Owner Change Order

Change Order Number: 003

City of Norman - North Base Complex Phase 1
1310-1380 DA Vinci Street
Norman, Oklahoma 73069

The Contract is hereby revised by the following items:

DRAWING TITLE
FLOOR PLAN - FLEET MAINTENANCE

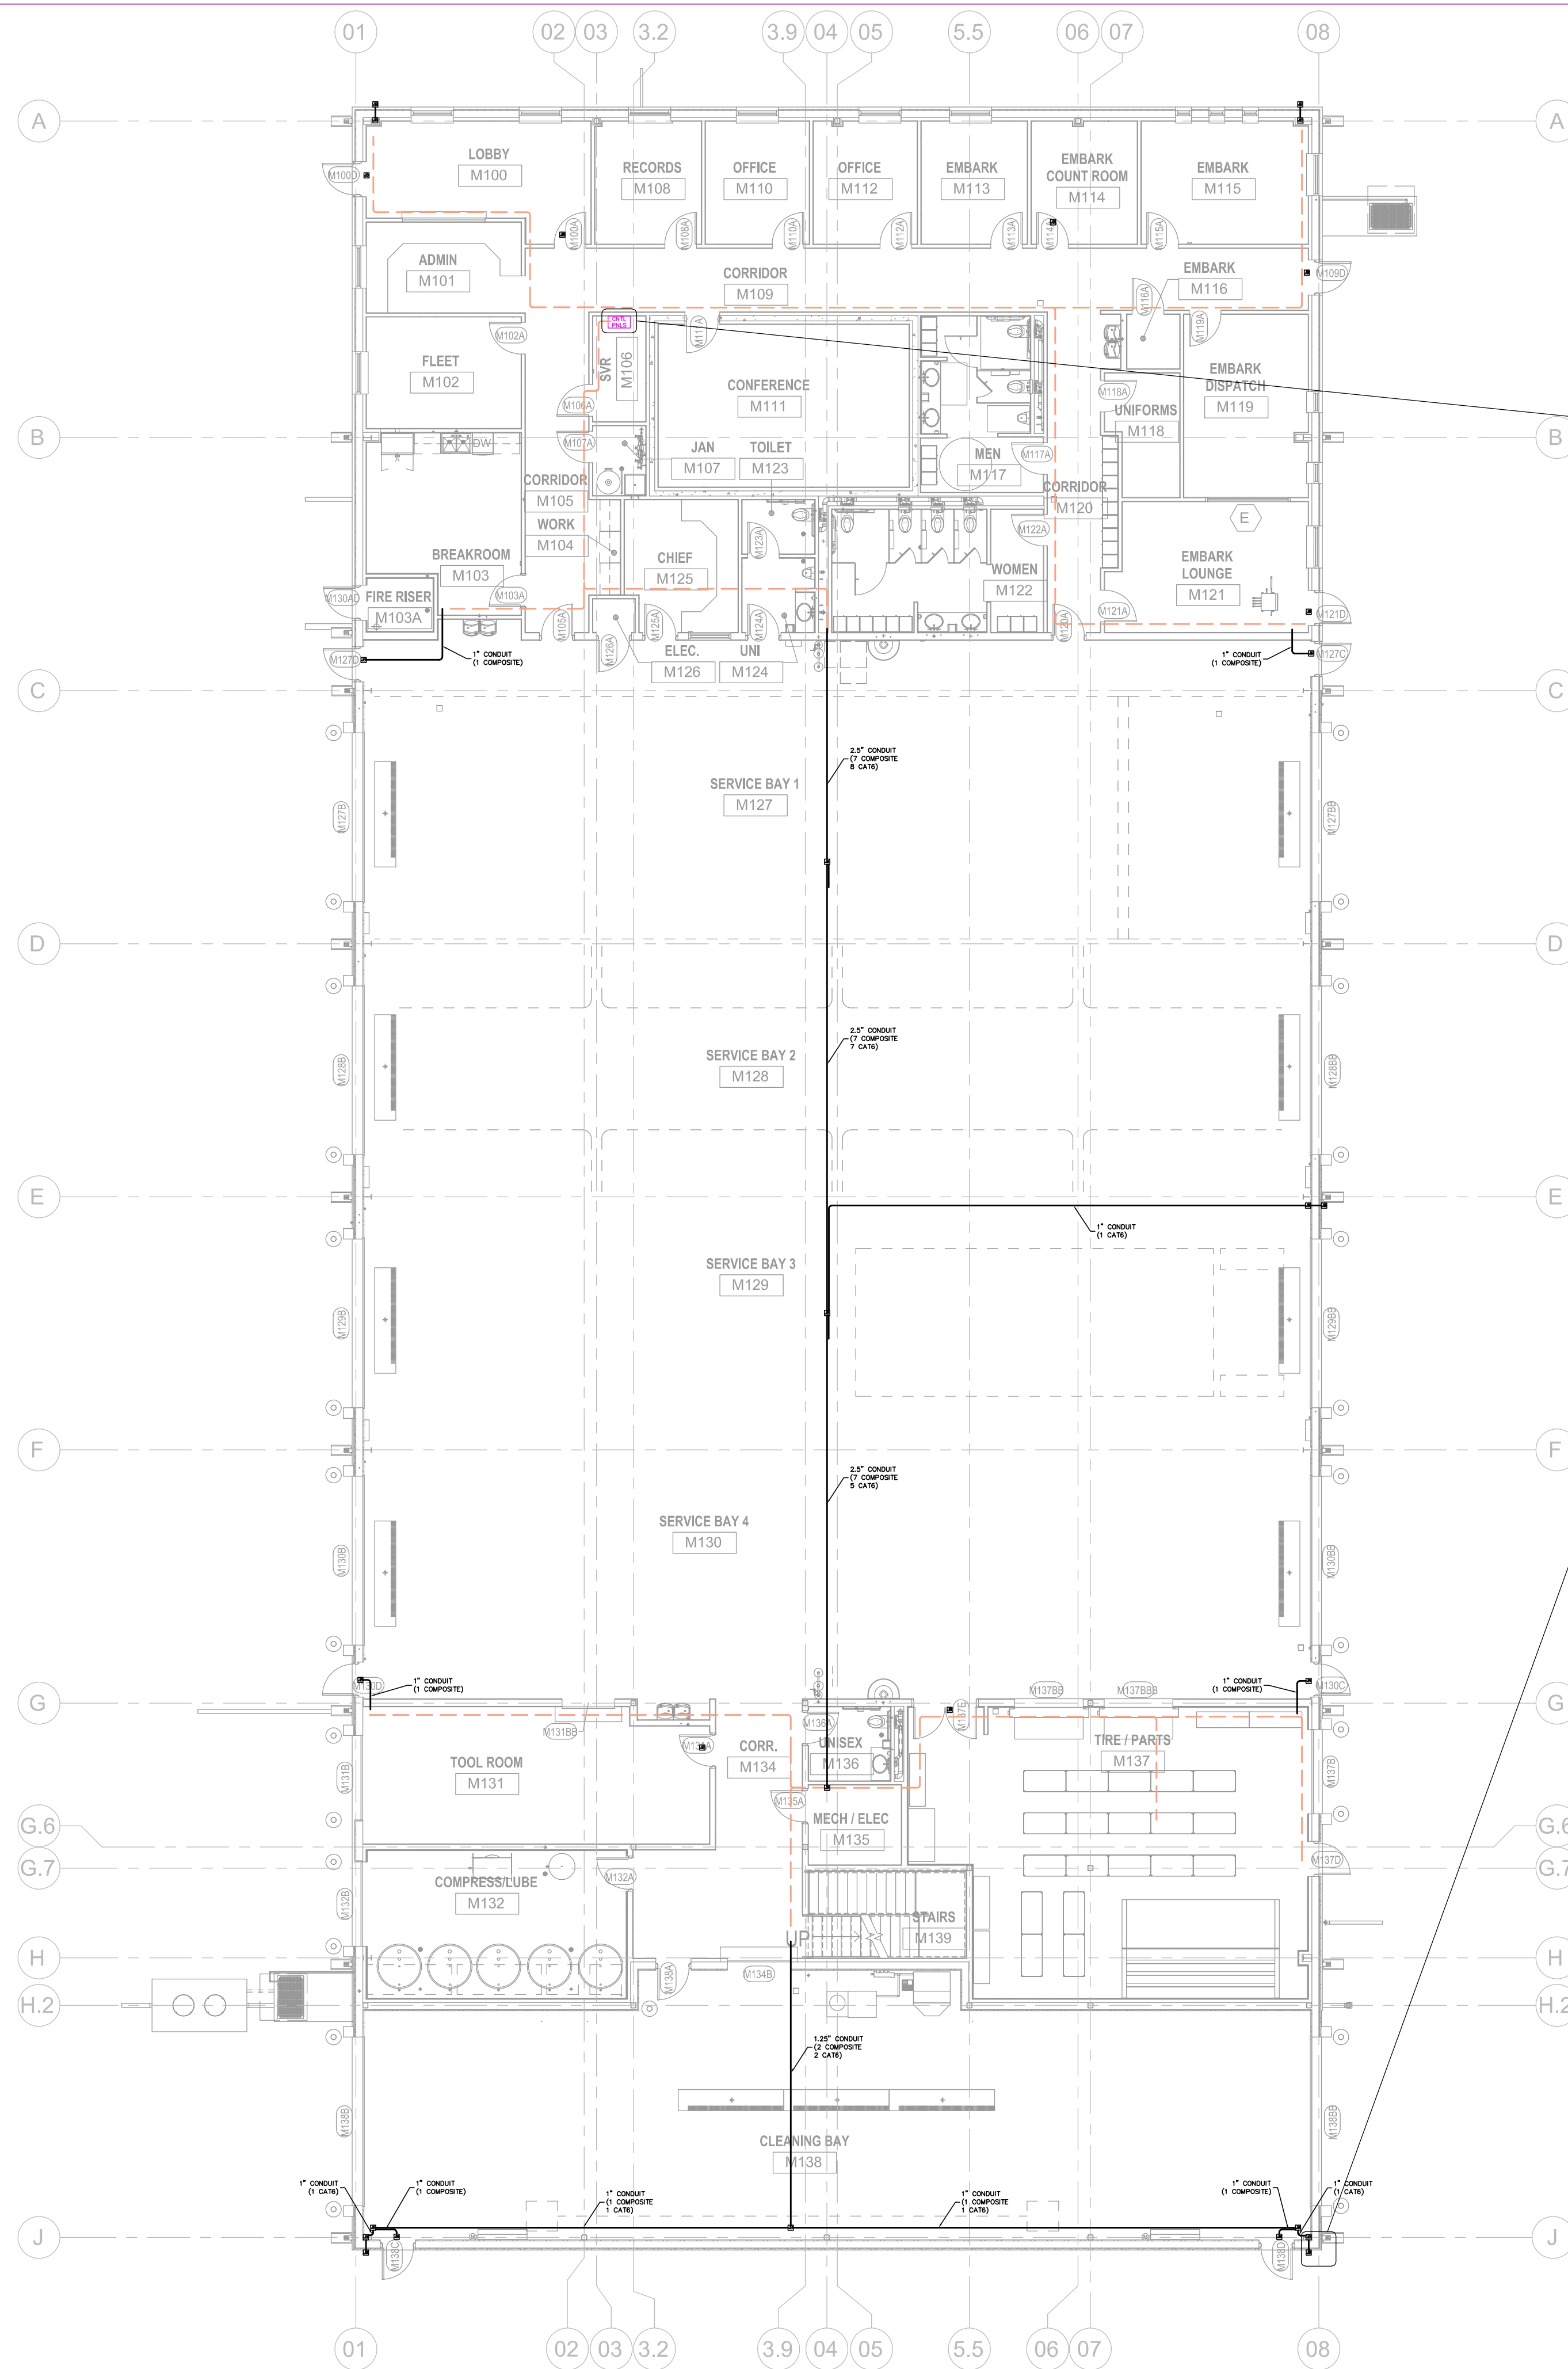
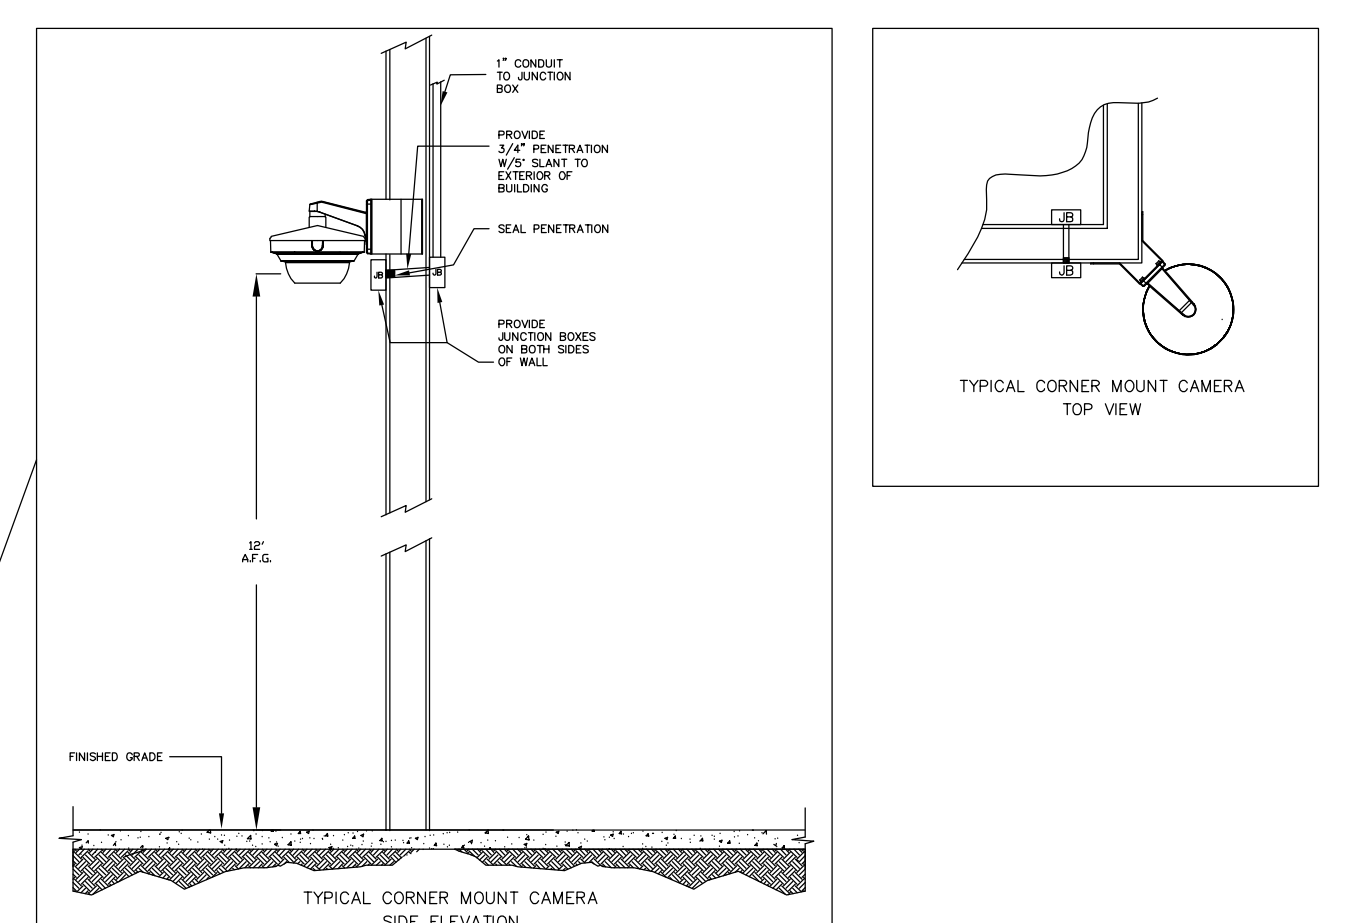
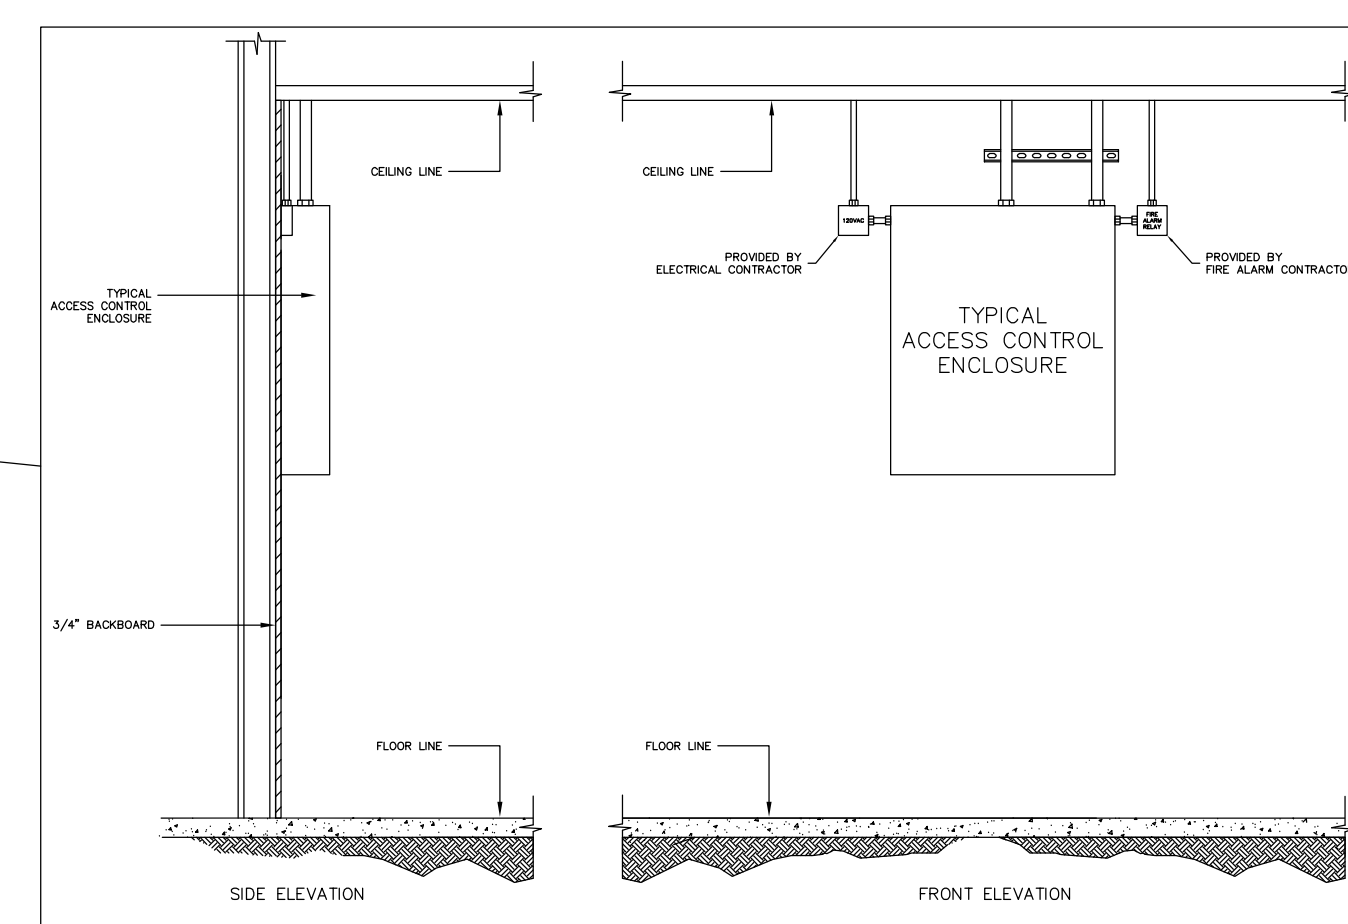
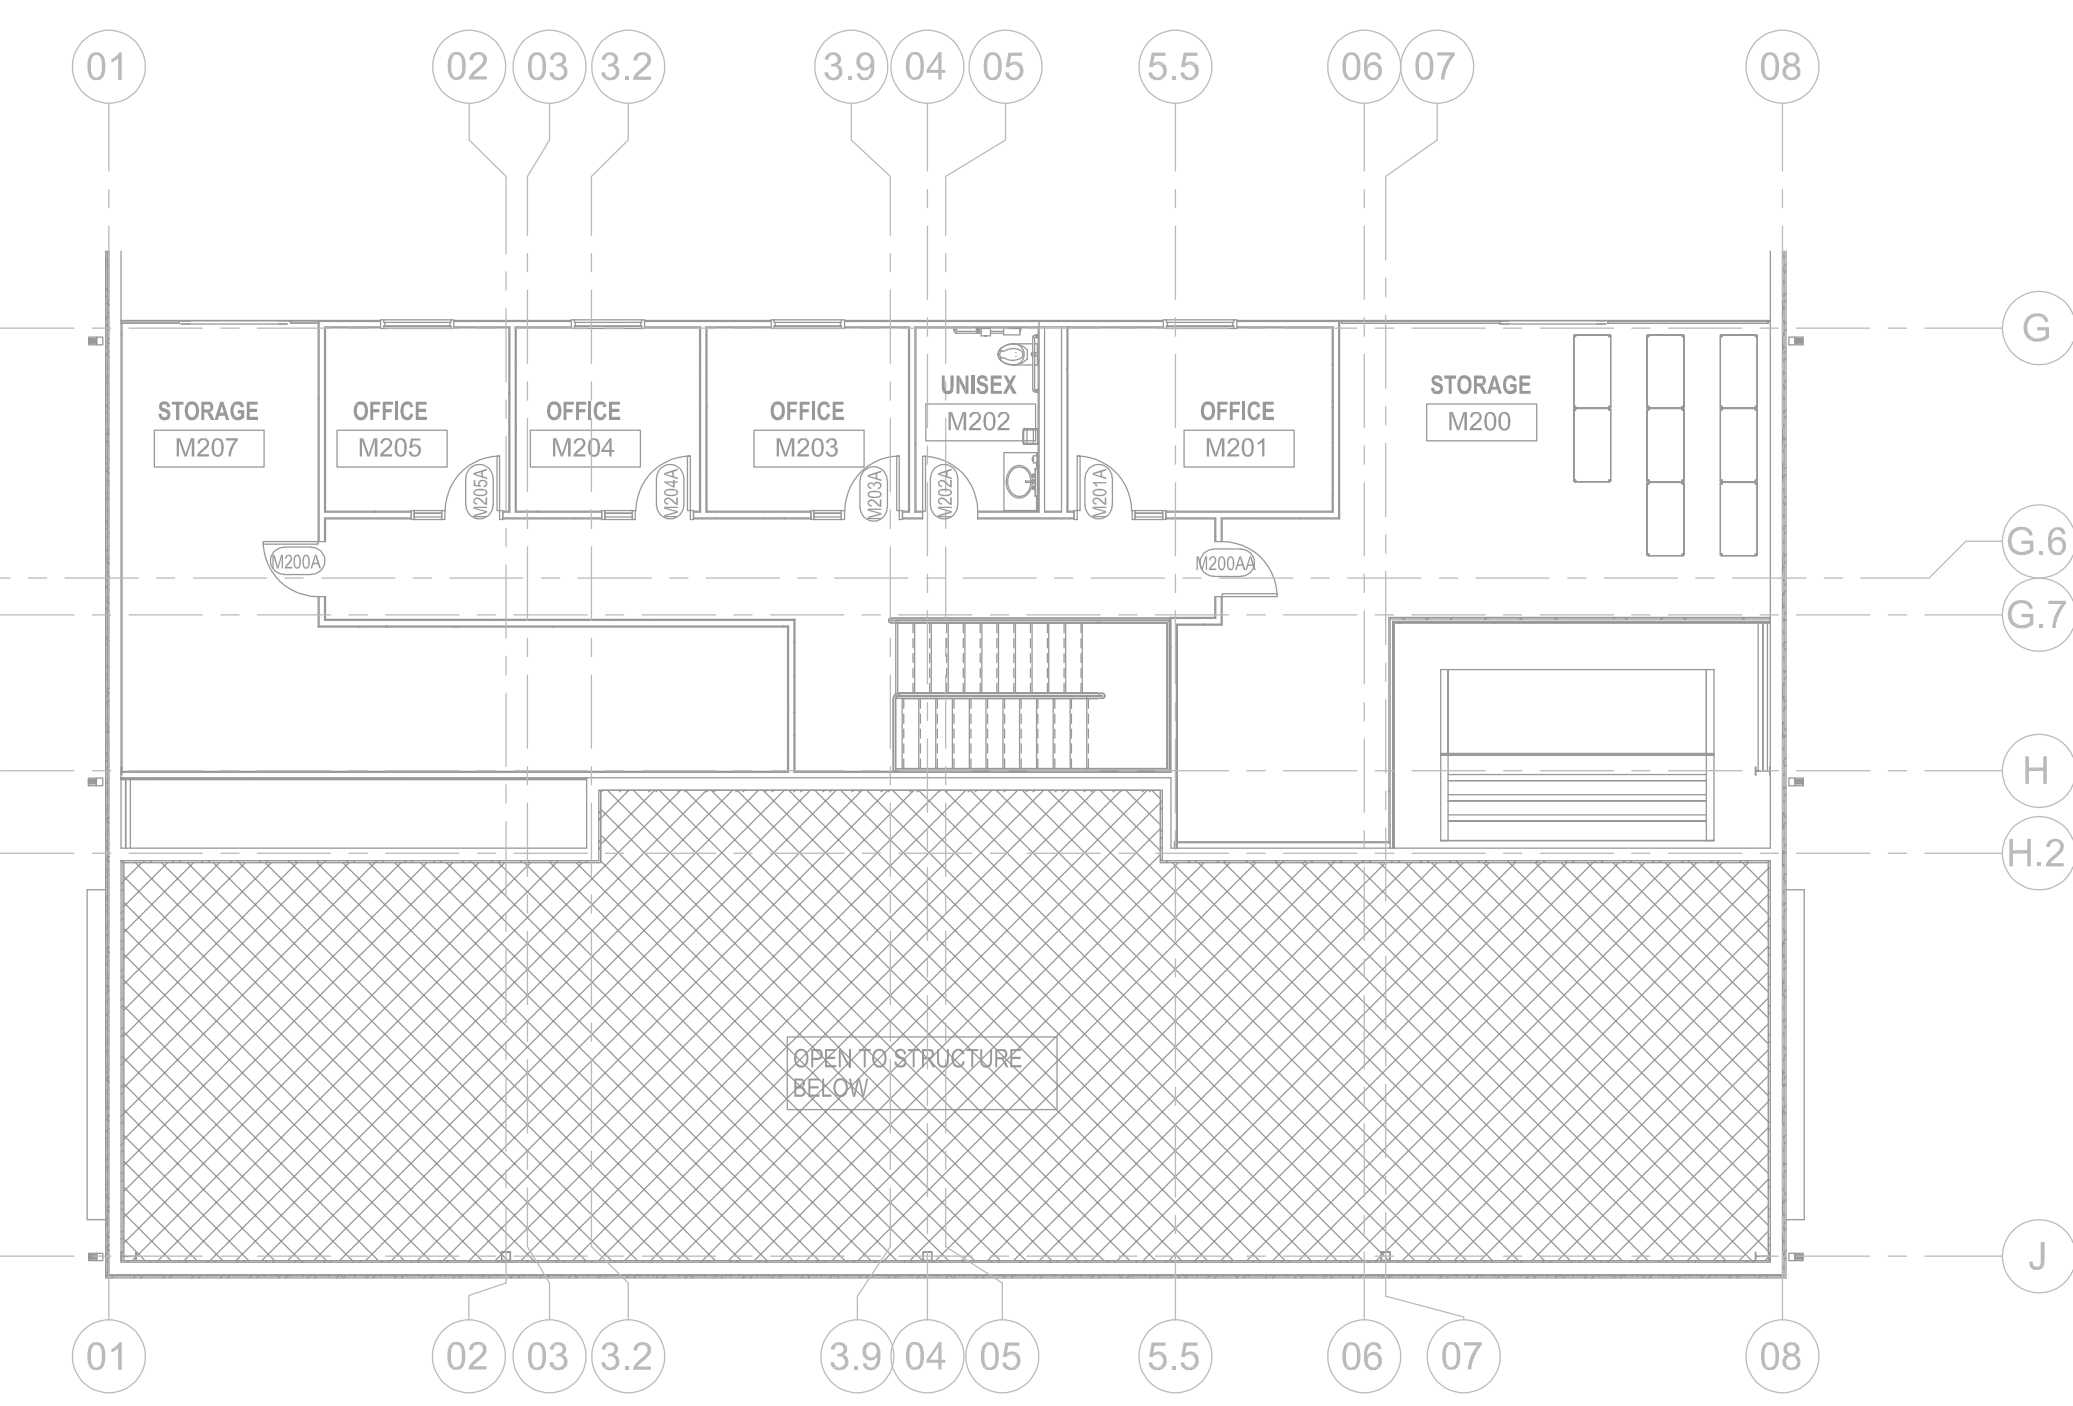
On May 27th, 2021, a coordination meeting was held with FLintco, City of Norman, and Convergent present, with the main topic regarding exposed raceways/cablings in the shop area. In the electrical drawings, general note "N" calls for the electrical contractor to provide all raceways shown on Convergent drawings. The raceways needed for convergent to get their cabling back to the comm room were not shown, and only the conduit required for the door access control was shown in the original Convergent drawings. After talking this through with Convergent, and Paul D'andrea, we all agreed that the access control wiring above dropped ceilings could be eliminated and Convergent's wiring could be free air with J-hooks in thos areas, eliminating the need for conduit above ceiling. The intention was to have a wash between eliminating the aforementioned conduit and adding the conduit across the shop/bay areas as shown in Convergints revised drawings, however, the revised conduit routing exceeds the original quote by approximately \$1500. Please advise if Flintco should proceed with installing the added conduit per the revised Convergent Drawings at an additional ROM of \$1500.

FLINTCO MAY PROCEED WITH THE INSTALLATION OF THE ADDED CONDUIT PER THE REVISED CONVERGINT DRAWINGS FOR THE ADD OF \$1,500.

FLEET MAINTENANCE
M117 + M130
18x36 TILE

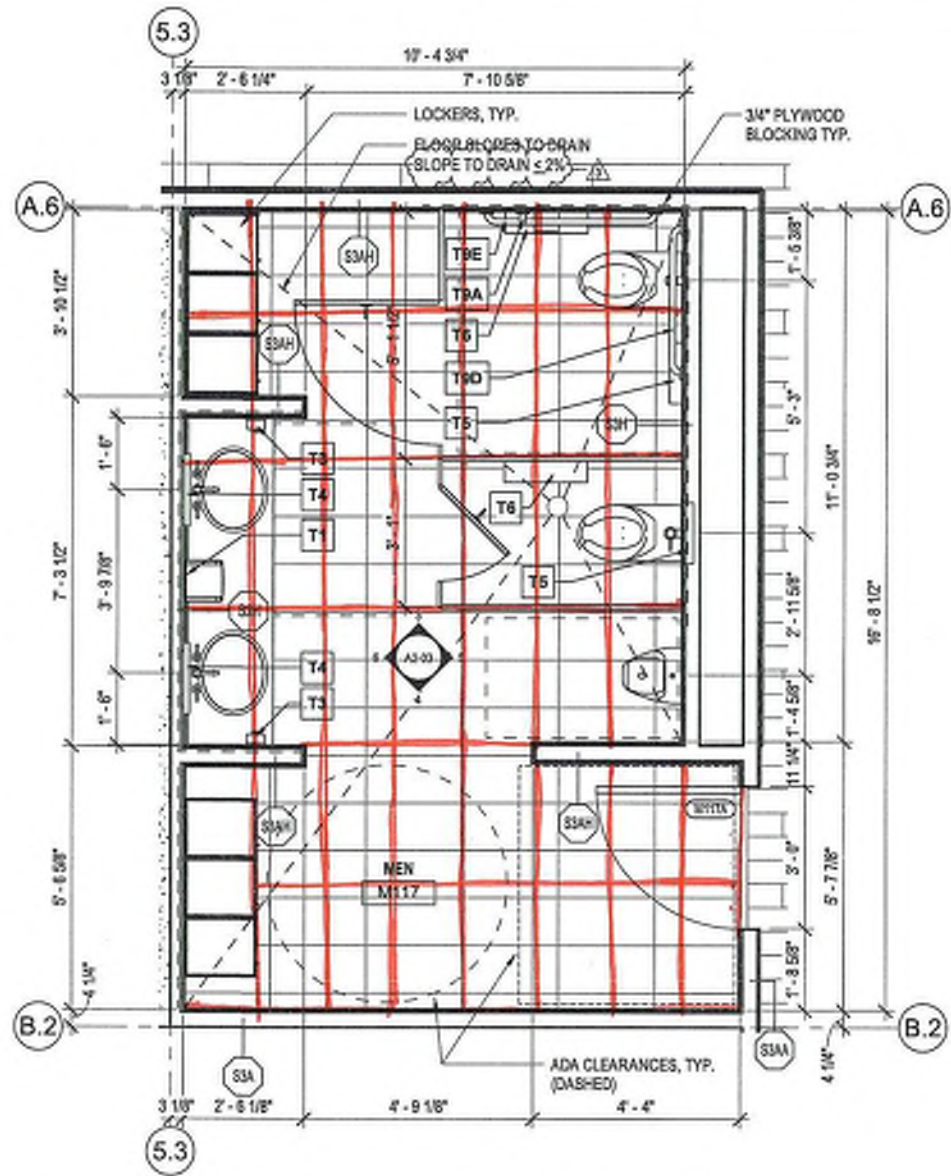
**TILE CHANGE
FROM 12x24
TO 18x35**

TOTAL ADD for 18x35 in lieu of specified 12x24.....\$ 1,561.00
